Subject: FUEL DENSIFICATION

CHANGE NO. 21 TO THE TECHNICAL SPECIFICATIONS

LICENSE NO. DPR-19

SAFETY EVALUATION OF THE
FUEL DENSIFICATION EFFECTS ON THE
DRESDEN NUCLEAR POWER STATION UNIT 2

FIGURE 3.5.1 MAXIMUM ALLOWABLE PLANAR LHGR

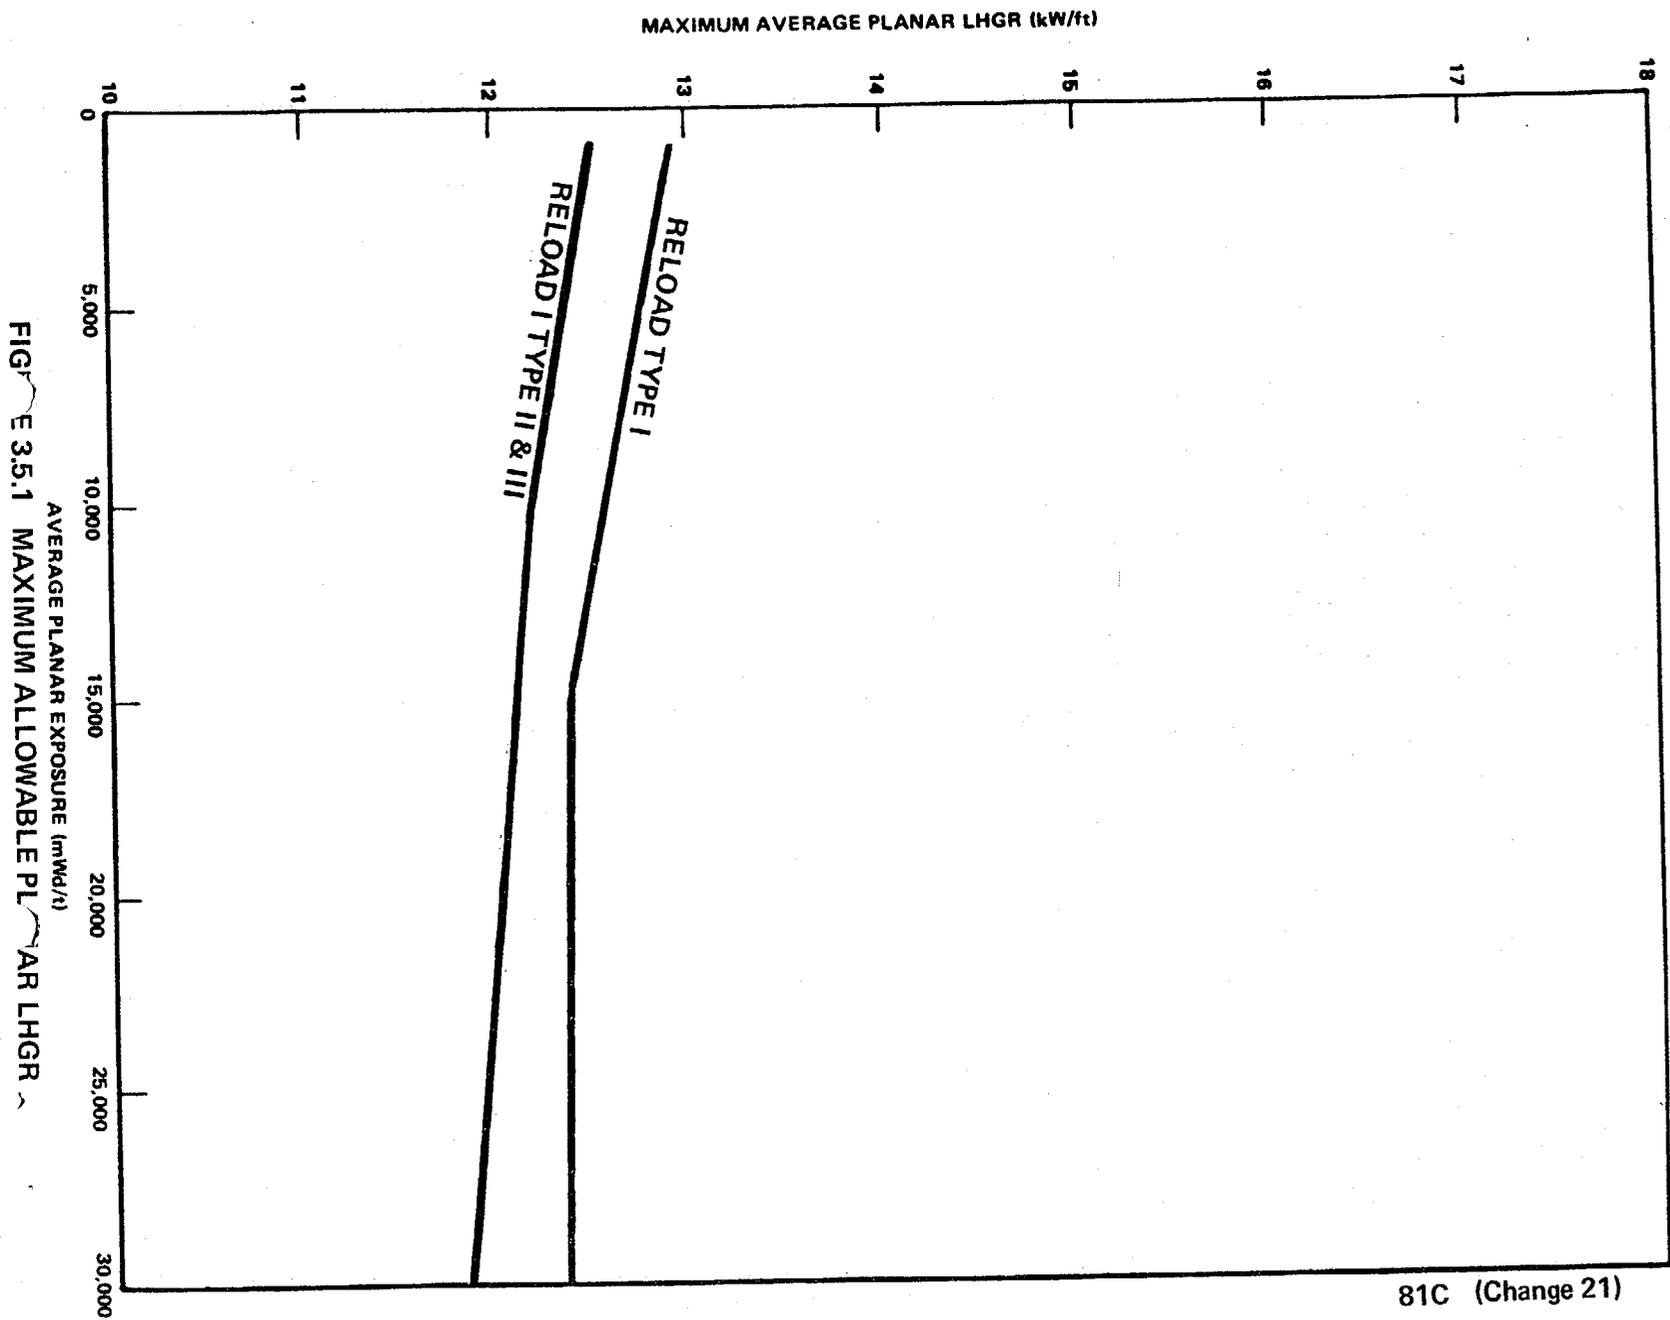
During steady state power operation, the average linear heat generation rate (LHGR) of all the rods in any fuel assembly, as a function of average planar exposure, at any axial location, shall not exceed the maximum average planar LHGR shown in Figure 3.5.1.

The maximum average planar LHGR shown in Figure 3.5.1 is the same as that shown on the curve labeled " γ " (gamma) on Figures 4-9H1 and 4-9H2 of the GE topical report "Fuel Densification Effects on General Electric Boiling Water Reactor Fuel," NEDM-10735, Supplement 6, August 1973 and is the result of the calculations presented in Section 4.3.4 of the same report. These calculations were made to determine the effect of densification on peak clad temperature and were performed in accordance with the AEC Fuel Densification Model for BWR's which is attached to NEDM-10735, Supplement 6 as Appendix B.
